Corner cases and Comments on EEE Clause 40

Sep 2008
IEEE 802.3az Task Force

IEEE 802.3az September 2008 Interim Meeting

Figure 40-15b—PHY Control state diagram, part b

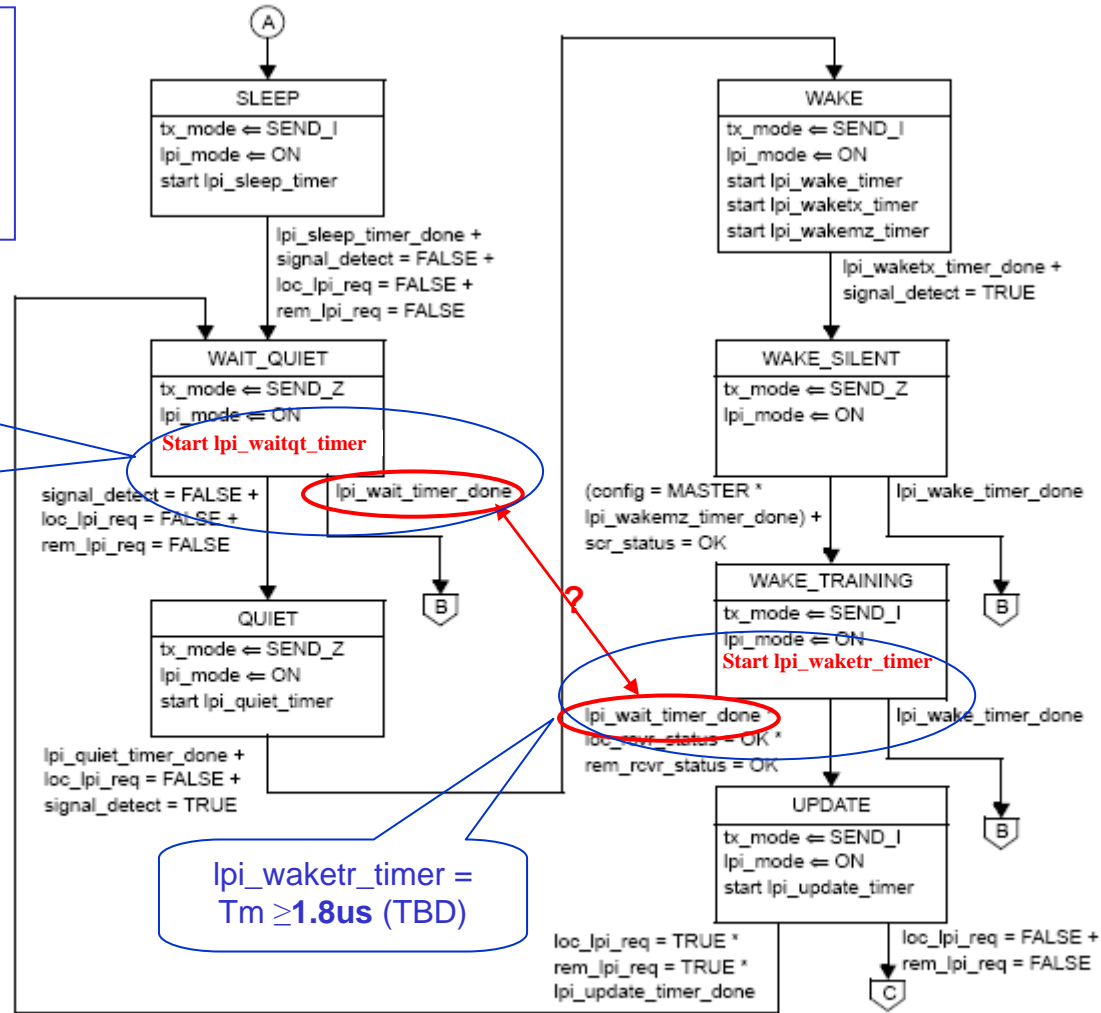
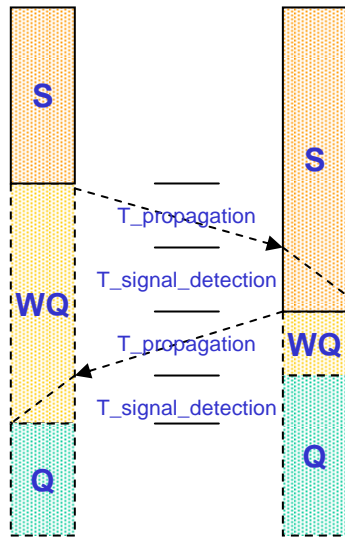
Comment 4: separate lpi_wait_timer

- Some intermediate LPI states need minimum time to transit and maximum time to break out
- Better to have separate timer for each state

lpi_waitqt_timer
 >>
 2 * propagation delay +
 2 * signal_detection time
 = 3.6us
Suggested value = 10us

lpi_waketr_timer = $T_m \geq 1.8us$ (TBD)

7 Case 1: LP1 is always Active, LP2 goes through all transition states

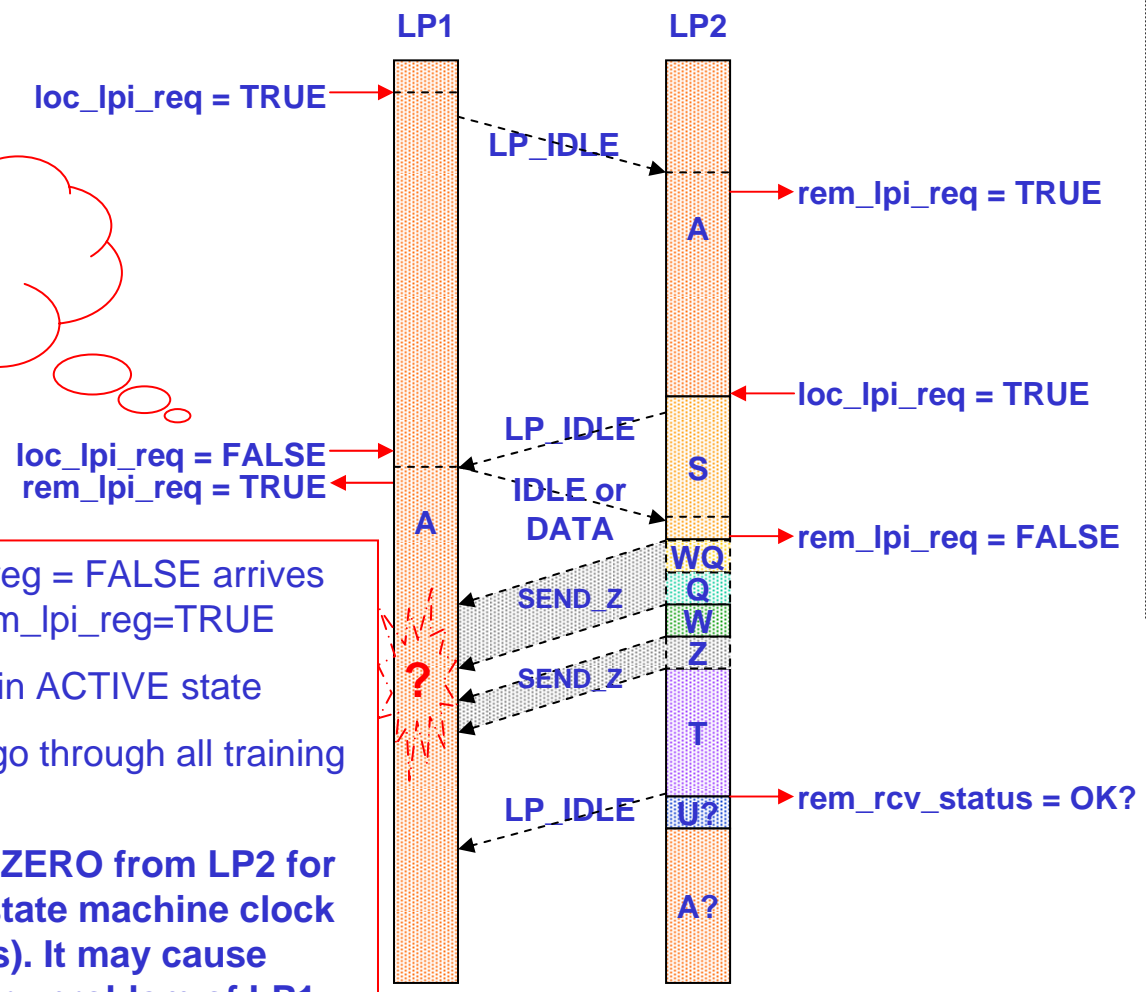
LP1 and LP2 have different understanding of current state

1. LP1's loc_lpi_req = FALSE arrives right before rem_lpi_req=TRUE
 2. LP1 is always in ACTIVE state
 3. LP2 needs to go through all training states
- LP1 will receive ZERO from LP2 for as long as 3 state machine clock period (120ns). It may cause timing recovery problem of LP1.

Case 2: LP1 returns to Active, LP2 goes through all transition states

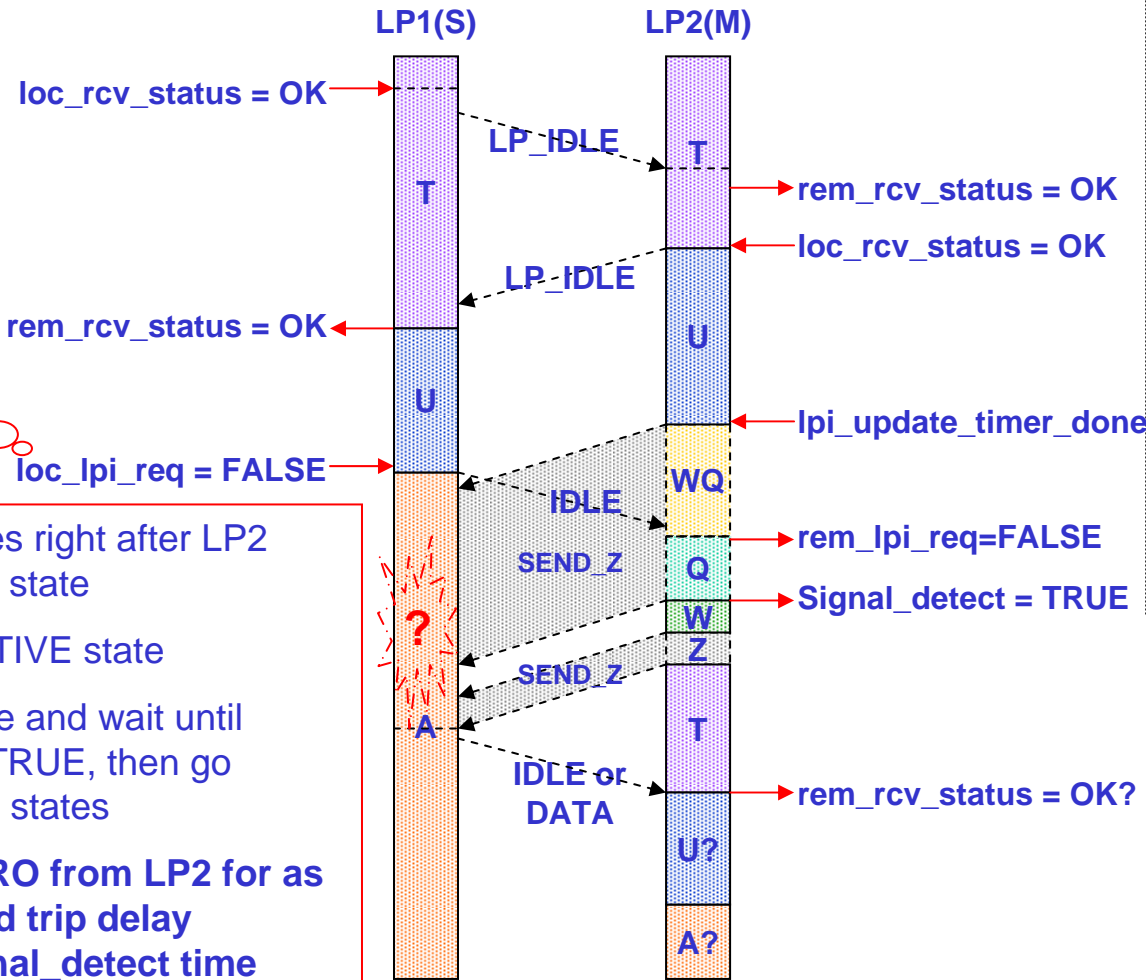
LP1 and LP2 move to different paths

1. LP2's ZERO arrives right after LP2 decides to exit LPI state
 2. LP1 returns to ACTIVE state
 3. LP2 in QUIET state and wait until signal_detection=TRUE, then go through all training states
- LP1 will receive ZERO from LP2 for as long as one round trip delay (~1.2us) plus signal_detect time (~1us) causing timing loop failure

Figure 40-15b—PHY Control state diagram, part b

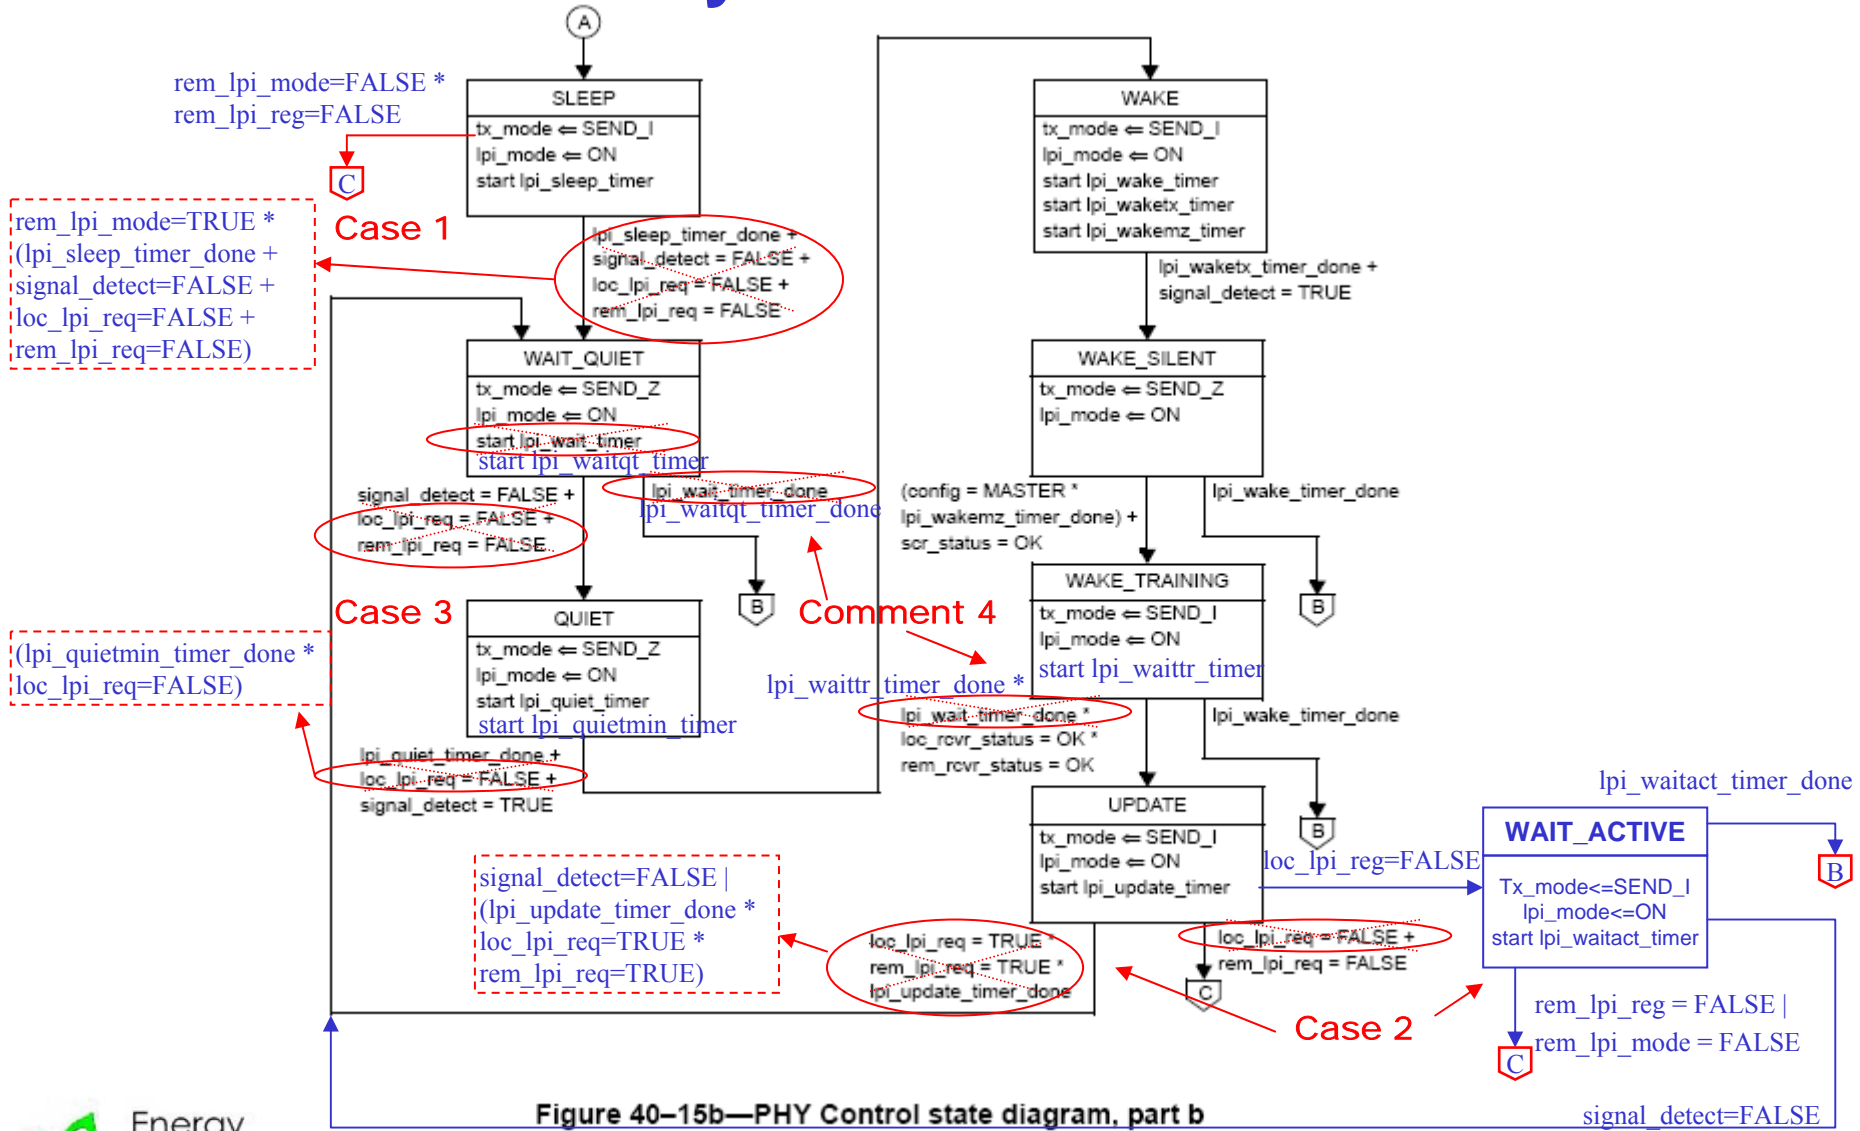
Comment 5 → Solution: Modify the State machine

- ❑ Encode lpi_mode signal in channel B output
- ❑ Force state SLEEP to exit to ACTIVE state if the remote party is deactivating LPI request (rem_lpi_reg = FALSE) in ACTIVE state. (case 1)
- ❑ Add a new state WAIT_ACTIVE between UPDATE and ACTIVE to avoid unwanted SEND_Z output by improved handshaking protocol . (case 2)
- ❑ Add a new watchdog timer lpi_waitact_timer (>3.6us, suggest 5us~6us)
- ❑ Add a new timer lpi_quietmin_timer (\approx signal_detect time=1us) to guarantee a minimum SEND_Z time during acceleration of state transition due to loc_lpi_reg=FALSE
- ❑ Forbid exiting from intermediate state WAIT_QUIET when local LPI request is de-asserted. (case 3)
